NUCLEAR ORGANIZATION
CONTROLLED DOCUMENT TRANSMITTAL NOTICE

DOCUMENT TITLE: EP-IP-240, EP-IP-259, EP-IP 410

PILGRIM NUCLEAR POWER STATION

Procedure No. EP-IP-240

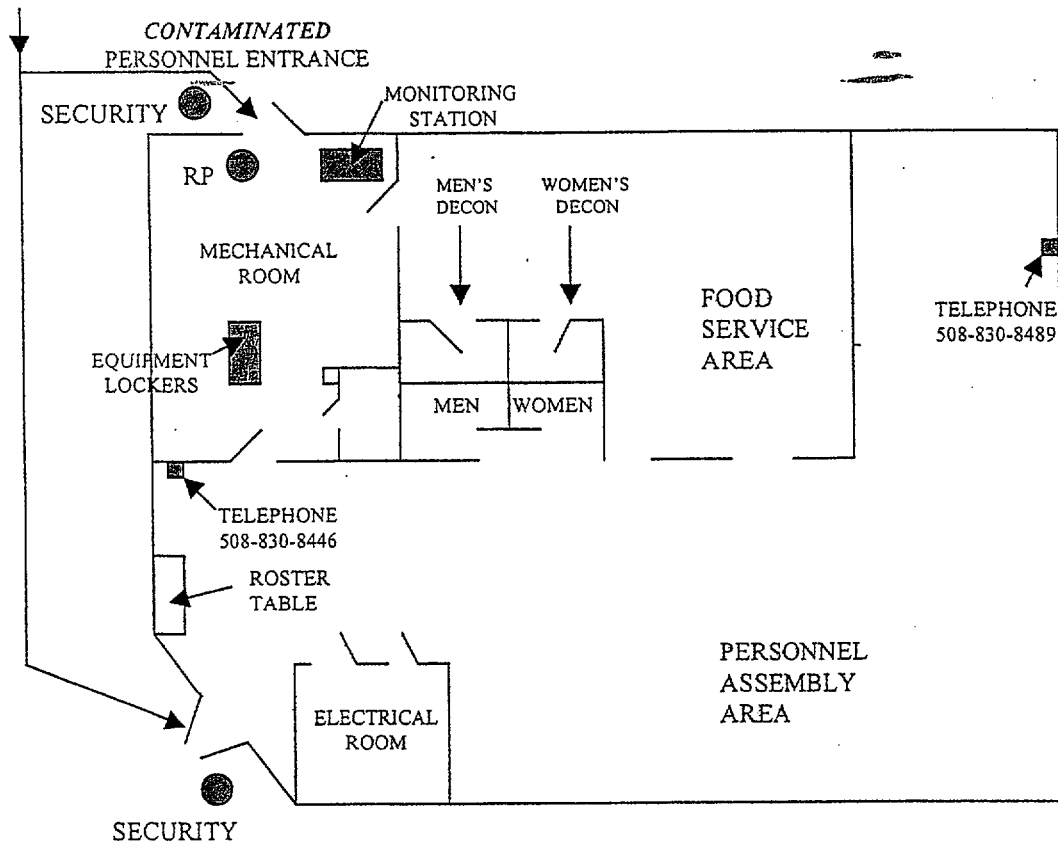
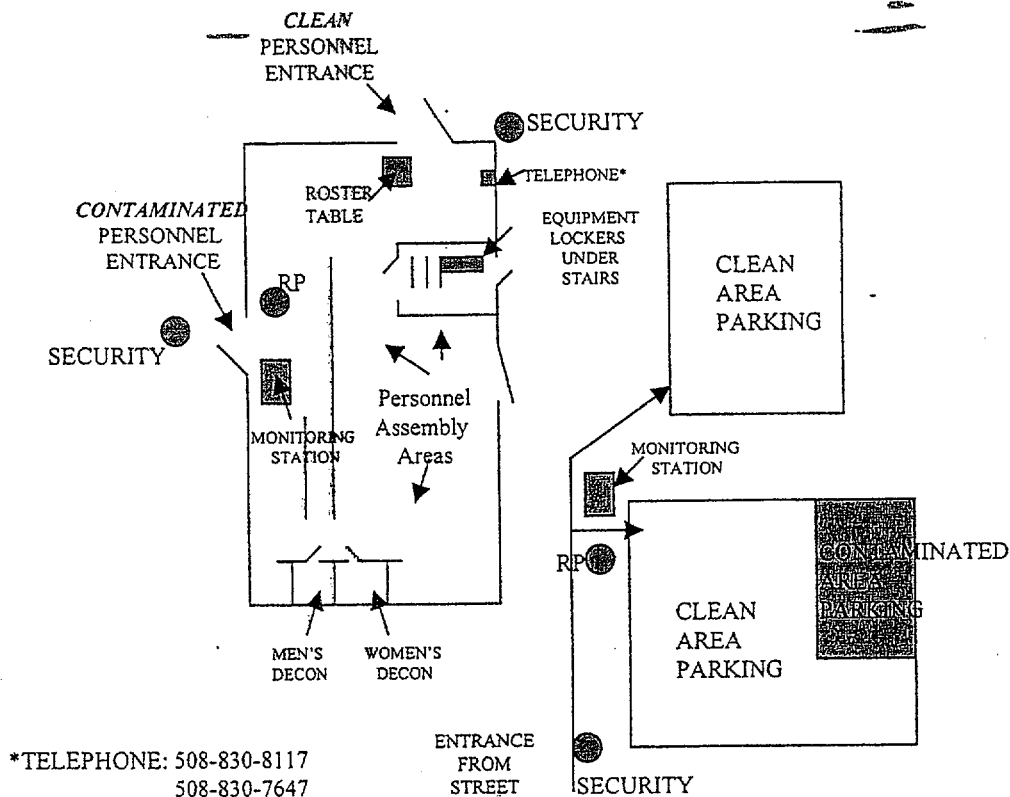
| 11-13 | Minor updates to Assembly Area floor diagrams and instructions. |
